**Moorebank Intermodal Precinct West - Stage 3 (SSD-10431)
Request for Additional Information**

The Department has reviewed the Moorebank Precinct West – Stage 3 Response to Submissions (RtS) (SSD 10431), dated 21 August 2020 (Aspect Environmental Pty Limited) and requests that you provide the following additional information.

Figure 1: SSD 5066 MOD 2 – Existing MPW Stage 2 operational boundary (left) and proposed amendment to operational boundary (right) (Source: Applicant’s SSD 5066 MOD 2 Modification Report).

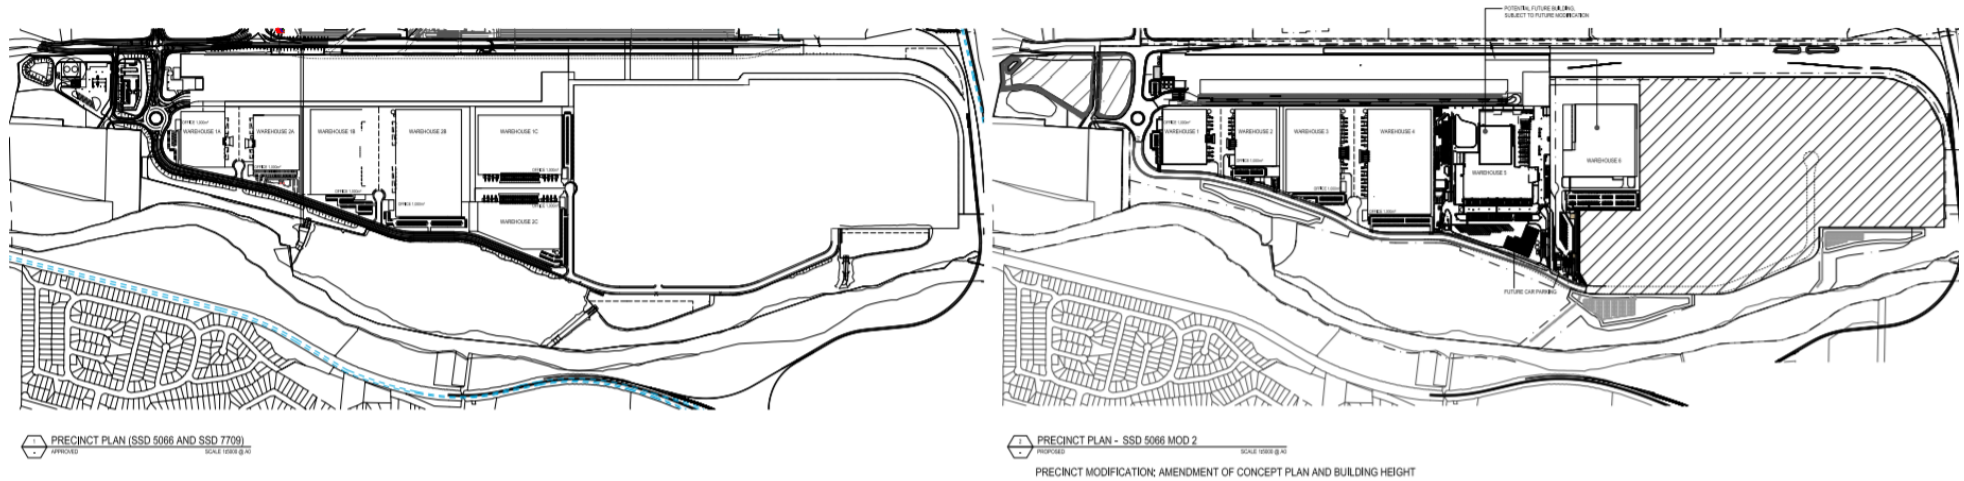
Please clarify as to whether the proposed subdivision configuration of lots 6 and 7 on the MPW Stage 3 subdivision plan are proposed to be amended to reflect proposed changes to the existing MPW Stage 2 warehouse configuration and operational boundary, as outlined in proposed SSD 5066 MOD 2 and SSD 7709 MOD 1 (see **Attachment 1**).
